ORDER UNDER SECTION 96 (2) OF ACT, III OF 1901.

Re: Plan of proposed building on plot No. 58,
A#16, Market Quarter.

With reference to ^{his}~~their~~ application dated 19-8-1925 with aplan for the proposal ^{a double storied} Building ~~additional~~ on plot No. ~~44~~ 58 Survey Sheet No. A.16~~Market~~ Quarter Mr. Adam Soomar is informed that

PLAN SHOWING PROPOSED BUILDING

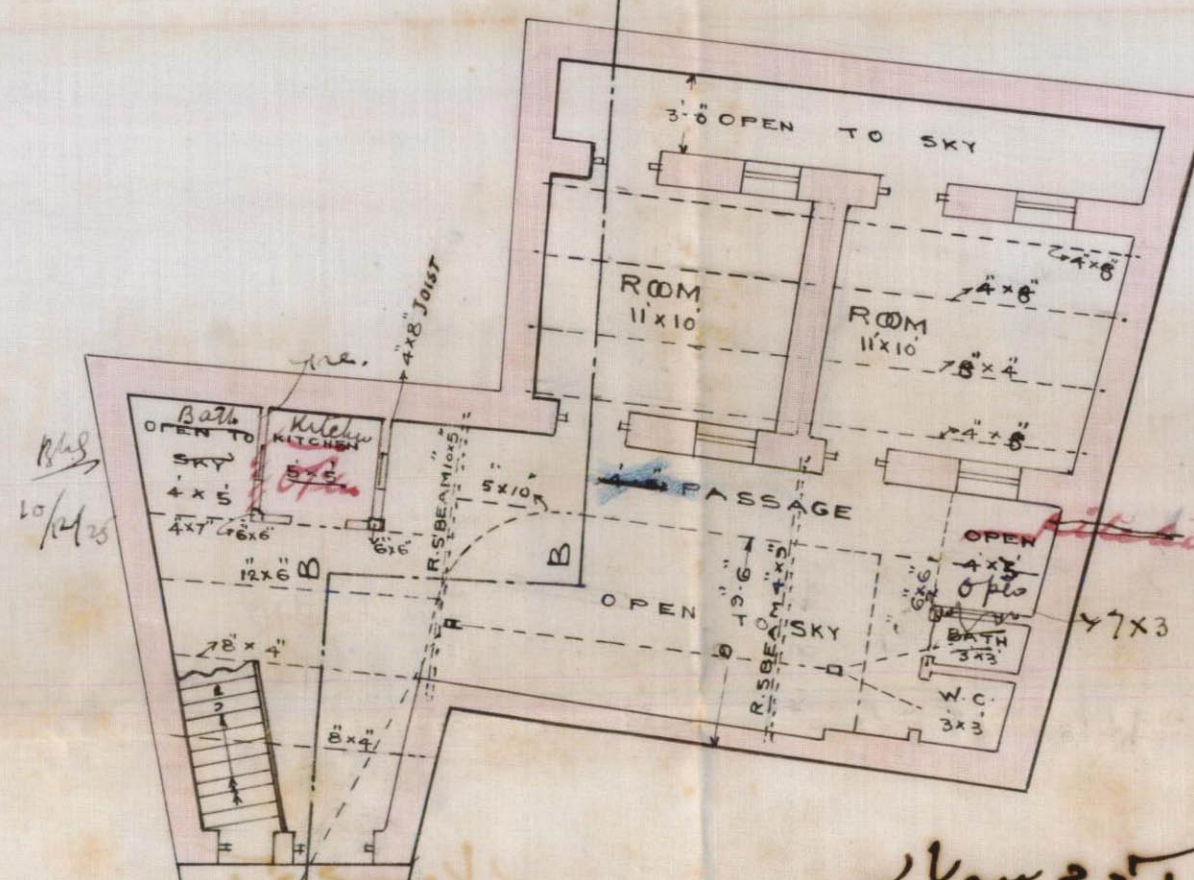
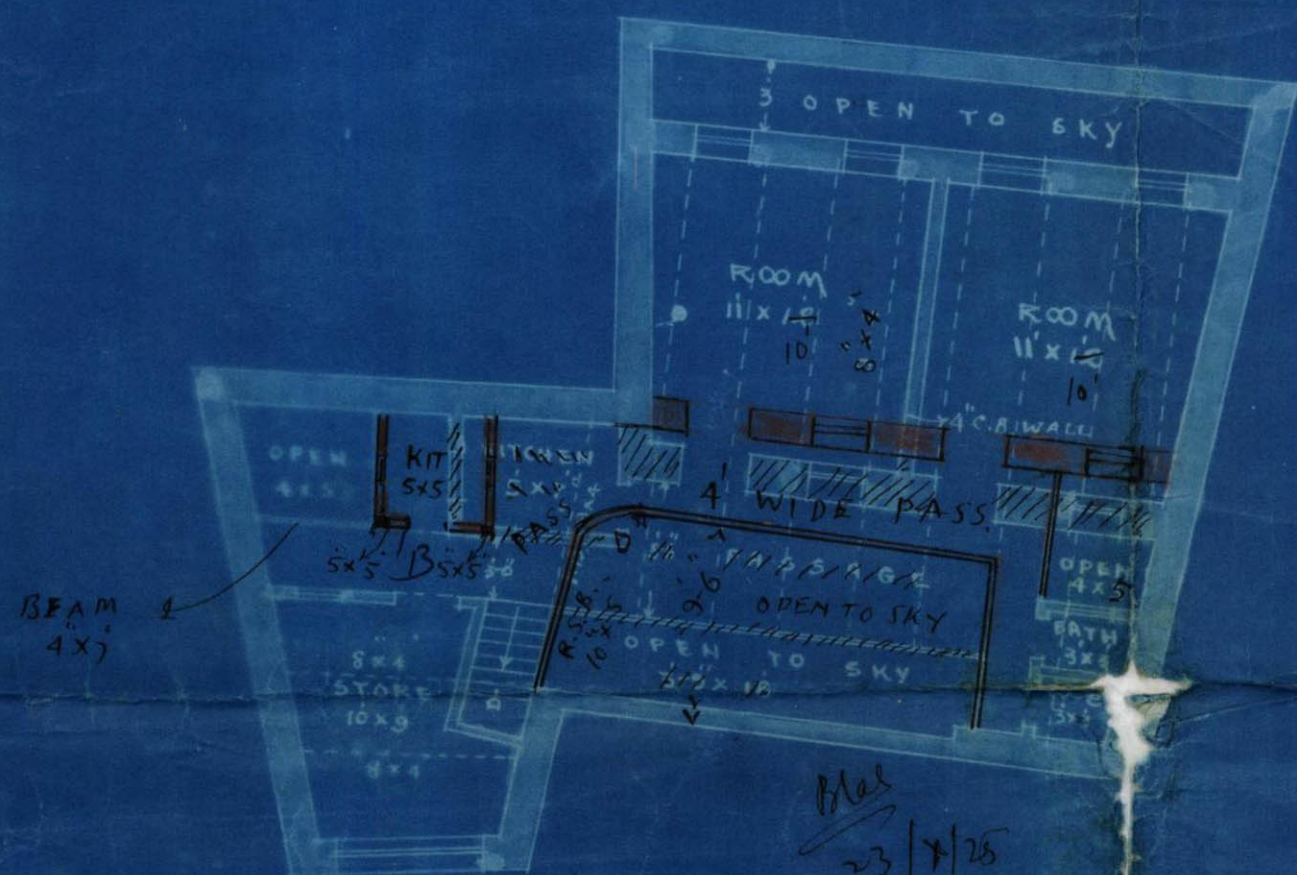
Mr. Beharilal Kewalram, Architect is hereby informed that he should remove all unnecessary lines from the plans of the above plot, specially from the open space and show the beams wherever required.

With reference to their application dated 15-9-25, Messrs: Beharilal Kewalram & Co., are informed that the planning must be changed to give proper air & light. The plans cannot be passed unless this is complied with. Undersigned would suggest him to omit one room and make the other a little bigger. The least open space must be 10 feet.

- (1) Title deed must be produced.
- (2) Building is not wall ventilated, the open space on Scaff must be increased to half the height of the building.
- (3) Rear wall open to sky should be shown on ground plan.
- (4) Side measurements must be shown as in the site plan as shown in pencil figures.
- (5) 12" x 6" beam must be provided below P. wall for 12 ft span
- (6) the joists must be spanned properly. 6" x 6" post on ground & 5" x 5" on 1st floor must be provided at A.
- (7) Beam B. must be 14" x 7"
- (8)
- (9)

- ① Tith deed must be provided
 ② Building is not well ventilated the
 space on S. must be increased to
 half the height of the building, ③
 Beam to 3, ④ do's other, ⑤ 12' x 6' beam
 must be provided below P. Wall for 12' spans.
 the joists must be spaced properly 6' x 6" Post
 on floor + 5' x 5" on floor must be provided
 at A. Beam B must be 14' x 7"

With reference to your letter No. L.M.A. 8465 dated 12th Sept. 25, the requirements are complied with as follows.-

Rear wall in G.F. Plan has been inserted.

Side measurements are shown

12"x6" beams are already inserted under walls where necessary.

Posts 6"x6" on G.F. and 5"x5" on 1st Floor placed at A

Beam at B about 14"x7" are also inserted, joists spread properly.

As regards open space on the South it is hereby pointed out that in case an attempt is made to leave an open space of width equal to half the height of the building, ^{viz 11'-6"} the area of the room enjoying such open space is reduced to one below 80 sq. ft. as against the Building bye-laws, whereas the utility of the building is killed forthwith.

Open spaces in various places have been opened duly and even now Rooms enjoy open spaces on both sides of total width of 8'-3", which ^{are compatible} is enough with regard to the shape and width of the building, which is only 2 storeys high.
